Notice of Market Rules Modification

Paper No.: EMC/RCP/139/2024/RC383

PAPER NO. : **EMC/BD/03/2024/02**

SUBJECT : **MODELLING OF ENERGY STORAGE SYSTEMS
(ARISING FROM CP86: RESERVE PROVISION BY NON-
SPINNING GENERATION FACILITIES)**

Illustration: Reserve Solution space under current modeling

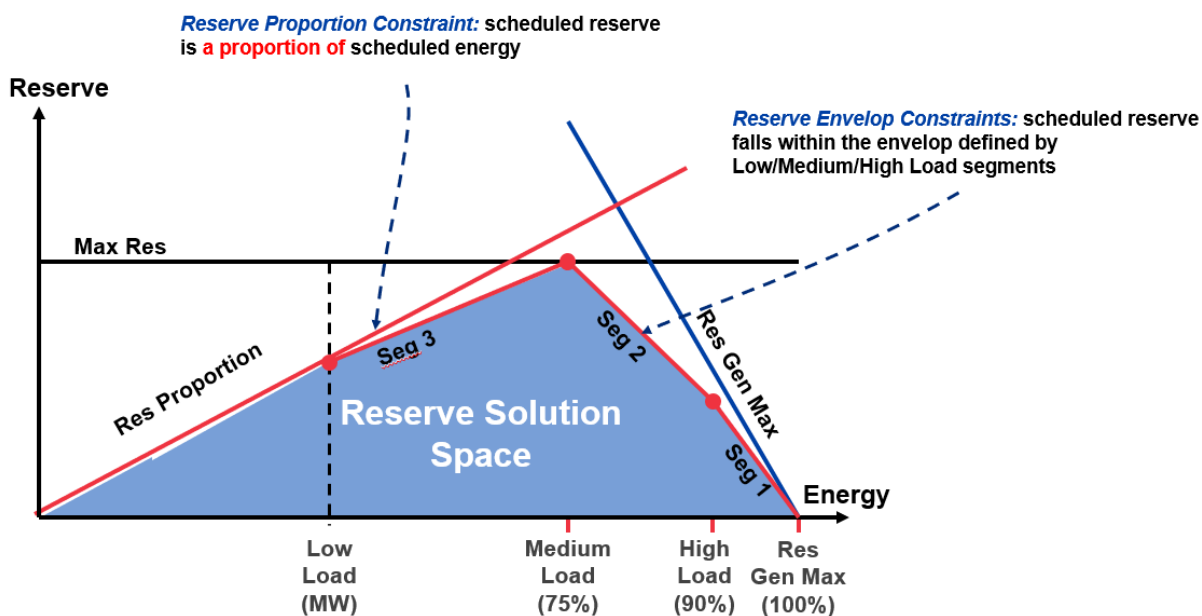
Issue 1: Reserve provision is unduly restricted for ESS due to ReserveProportion constraint and Reserve Envelope constraints

Currently, when providing reserves, all GRFs are bound by a ReserveProportion constraint, which means that the maximum reserve scheduled is directly proportional to the energy scheduled. For example:

- If ReserveProportion is 10 and energy schedule is 10MW, the maximum reserve schedule is 100MW
- Similarly, if ReserveProportion is 10 and energy schedule is 0MW (or negative MW), the maximum reserve schedule is 0MW

In other words, ESS currently need to be scheduled for some energy before they can provide any reserves. However, as noted previously by the RCP and Technical Working Group, ESS are capable of providing reserves even when energy schedule is zero or negative.

In addition, the current modeling of the reserve envelope, which is defined based on GRFs' reserve capability at HighLoad/MediumLoad/LowLoad points, are not applicable to ESS either. With ESS fast ramping capability, its reserve capability should only be restricted by its maximum discharge and charge limits.

Illustration: Proposed reserve solution space for a 10MW ESS

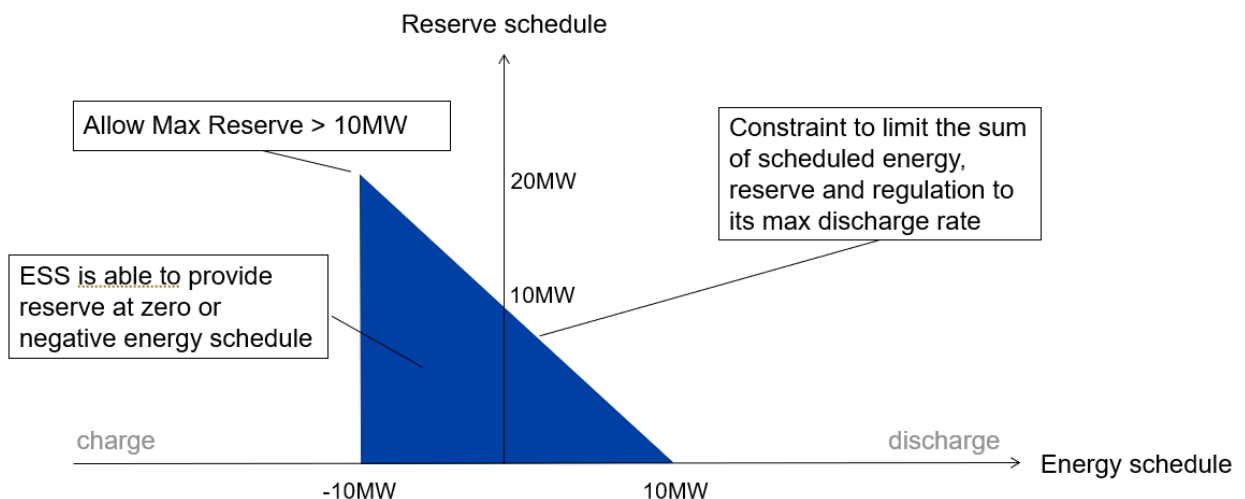
Issue 2: Reserve provision is unduly restricted for ESS to rated capacity when charging

Currently, GRFs are only able to provide reserve up to the rated capacity of the facility. However, for a ESS that is charging at maximum capacity, it is possible to provide reserves of up to twice its rated capacity. For example, for a 10MW rated ESS, ramping from -10MW (charging) to +10MW (discharging) essentially provides 20MW of reserve.

The ReserveProportion constraint and Reserve Envelope constraint should be removed for ESS. Furthermore, the maximum reserve capability for ESS should be allowed to exceed ESS rated capacity (but still subject to PSO approval for standing capability data).

An illustration of the proposed reserve envelope for a 10MW ESS is provided below.

In order to reflect the proposed solution illustrated above, the following constraint needs to be introduced for the modelling of reserve from ESS.

a. Energy Storage Reserve Max Constraint

This is to limit total schedule of energy (can be either positive or negative), reserve and regulation from ESS to its maximum capacity – please refer to 6D.17.2.4A in Annex 1 for more details.

Illustration: Proposed regulation solution space for a 10MW ESS

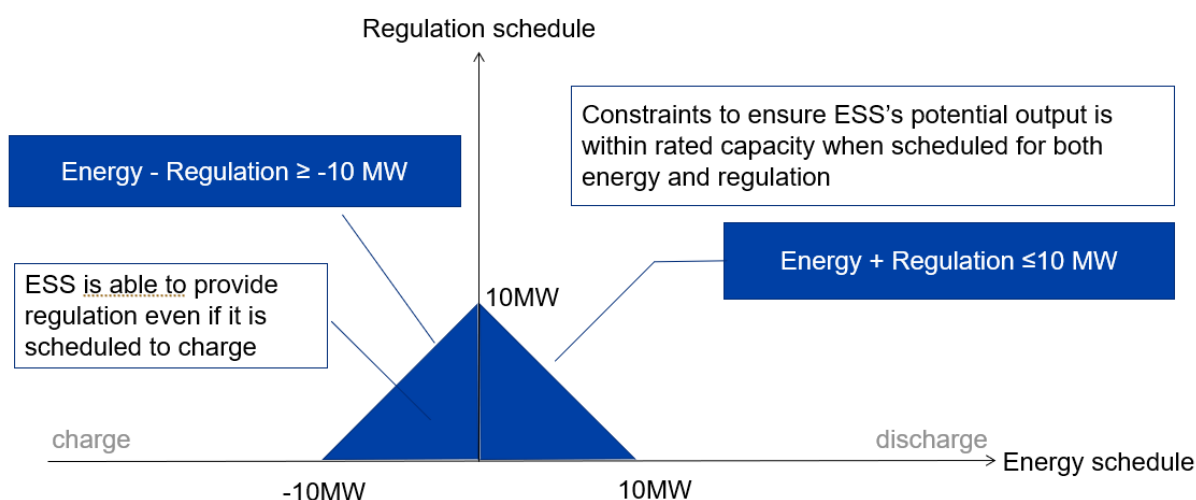
Mixed Integer Program (MIP)-based regulation constraint is not required for ESS

Currently, when providing regulation, a conventional generation facility needs to operate within its regulation range, which is defined by its RegulationMin and RegulationMax parameters. For conventional generation facilities, if its energy schedule is outside the regulation range, it will not be able to provide any regulation at all. As such, a set of MIP-based regulation constraints⁵ were put in place to model the provision of regulation from conventional generation facilities.

ESS, with its fast response capability, is able to provide regulation throughout its operating range. Therefore, the only constraint required for the modelling of regulation provision from ESS is to

limit the ESS’ output (when providing both energy and regulation) to be within its maximum discharge and charge limits.

An illustration of the proposed regulation envelope for a 10MW ESS is provided below. For ESS, its maximum regulation capability will typically be the same as its maximum capacity – when its energy schedule is zero.

In order to reflect the proposed solution illustrated above, the following constraints need to be introduced for the modelling of regulation from ESS.

a. Energy Storage Regulation Max and Min Constraint

This is to limit the energy storage facilities’ output to its regulation range when providing both energy and regulation – please refer to 6D.18.1.6 and 6D.18.1.7 in Annex 1 for more details.
